Service Bulletin

- Title:** AS350 Air Conditioner Compressor / Transmission Strut Interference. (Flat Belt Configuration)
- Subject:** This service bulletin addresses the upgrade of existing AS350 Air Comm Corporation compressor drive installations to preclude contact between the air conditioning compressor pulley and the L/H aft transmission support tube.
- Date:** 2 April 2009
- Applicability:** Eurocopter Model AS350 B, B1, B2, BA, B3, C, D, and D1 equipped with Air Comm Corporation air conditioning. (Flat Belt Configuration) Air Comm Corporation Serial number AS350-001 through AS350-043
- Reference:** 1) STC. Number SR00643DE, AS350 Cabin Air Conditioner
2) ACC Drawing Number AS350-300 Compressor Installation Rev L
3) ACC Drawing Number AS350-200 Air Conditioner General Arrangement Rev D
- Compliance:** Mandatory within 100 hours of receipt of this bulletin.

Figure 1 Compressor to Transmission Support Tube Clearance
(View looking outboard)

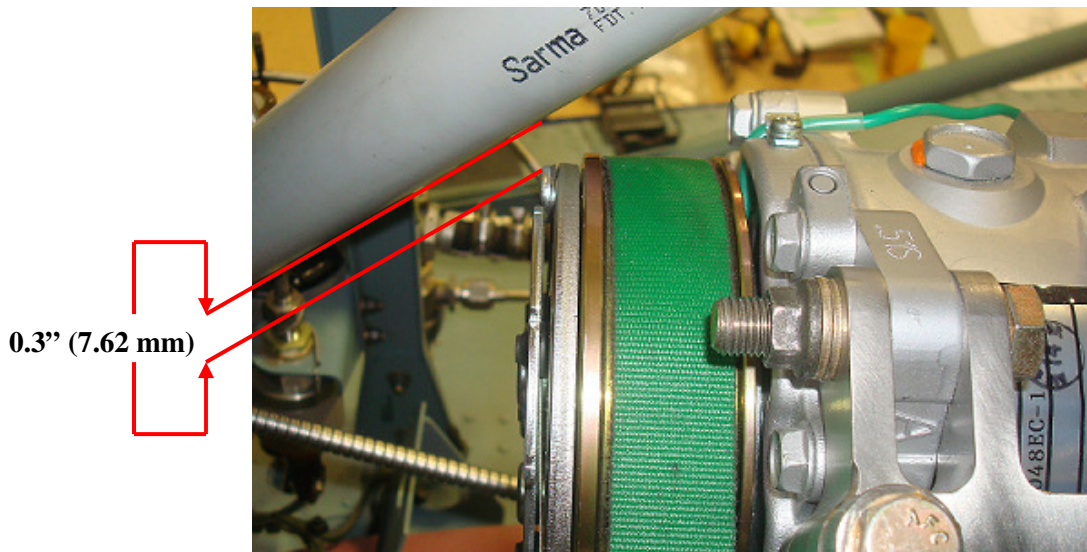
1. Locate the S-3048EC-1 compressor assembly and inspect for a minimum of 0.3” (7.62 mm) clearance between the L/H transmission support tube and the face of the S-3048EC-1 Compressor Pulley (See fig 1).
 - a. If 0.3”(7.62 mm) of clearance is observed DO NOT perform steps 5 and 6 of the accomplishment instructions.
 - b. If 0.3”(7.62 mm) of clearance is not observed proceed to step 2 of the removal instructions.

Figure 2 Rubber Sheet and Clamp installation
(View Looking Aft)

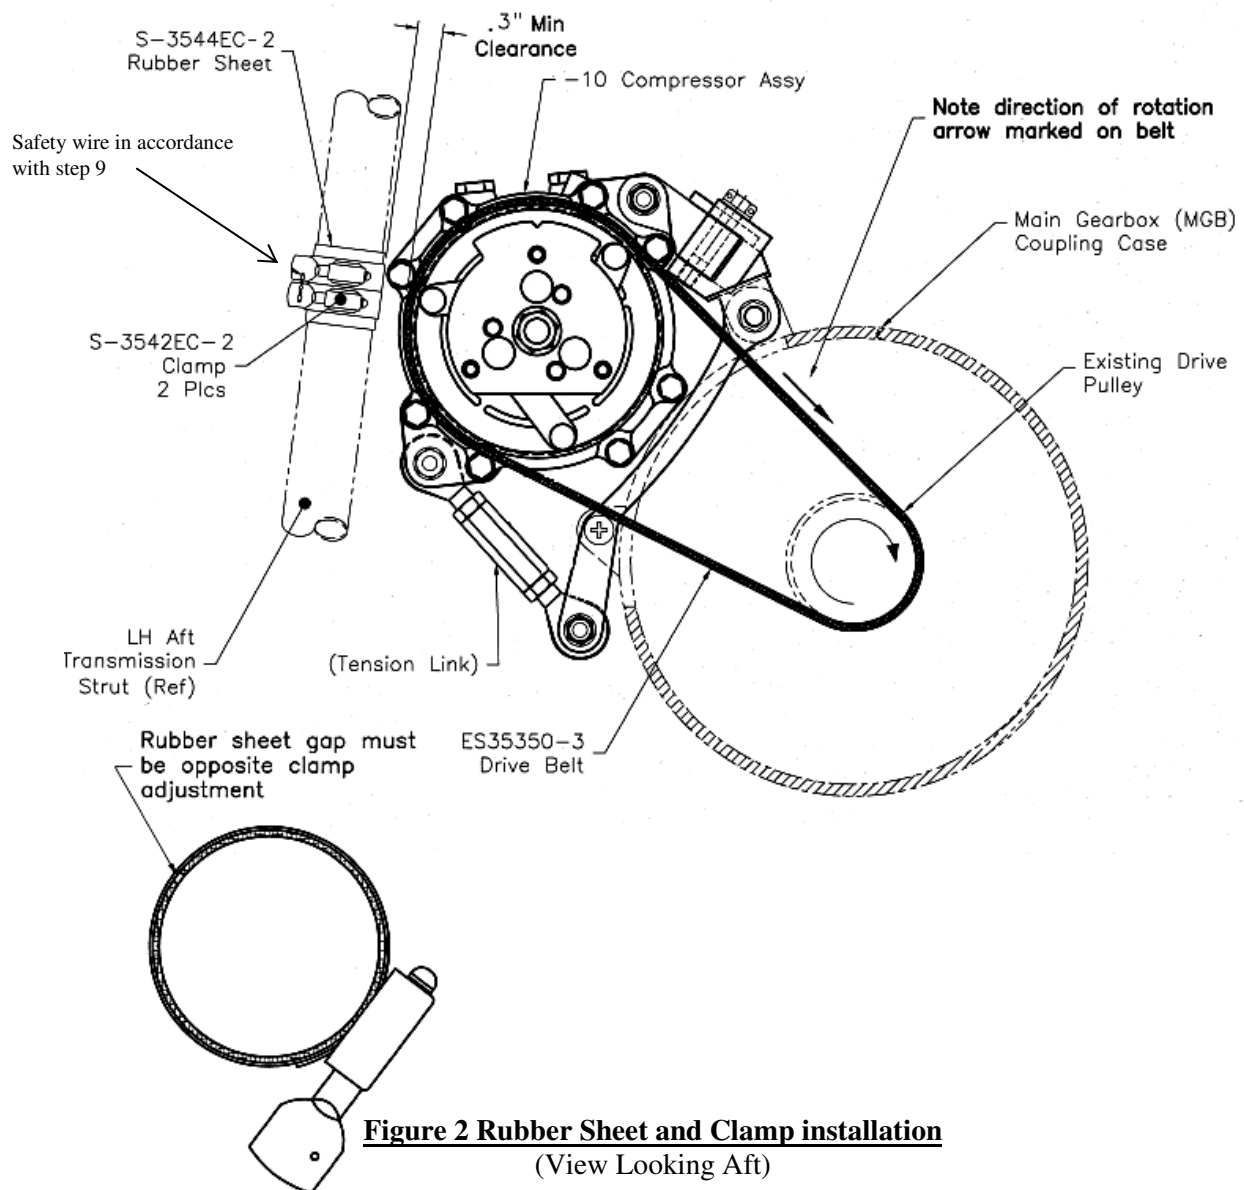
6. Install the new ES35350-3 drive belts onto the tail rotor drive shaft. Stow QTY 1 in accordance with the AS350-200M-1 air conditioner ICA and reassemble the tail rotor drive shaft in accordance with applicable AS350 maintenance manual.
7. Install the ES35350-3 drive belt onto the air conditioning compressor assembly and adjust belt tension in accordance with the AS350-200M-1 air conditioner ICA. Torque the compressor pivot bolts (QTY 2) to 160-190 in.lbs (18.07-21.46 nm)
8. Replace the safety wire removed in step 3 using MS20995 C32 safety wire in accordance with NASM33540 or equivalent.
9. Using the mark from step 5 center the S-3542EC-2 rubber sheet and install using QTY 2 S-3542EC-2 clamps. (Ref Fig 2) Safety wire the S-3542EC-2 clamps using MS20995 safety wire in accordance with NASM33540
10. Return air conditioner to service
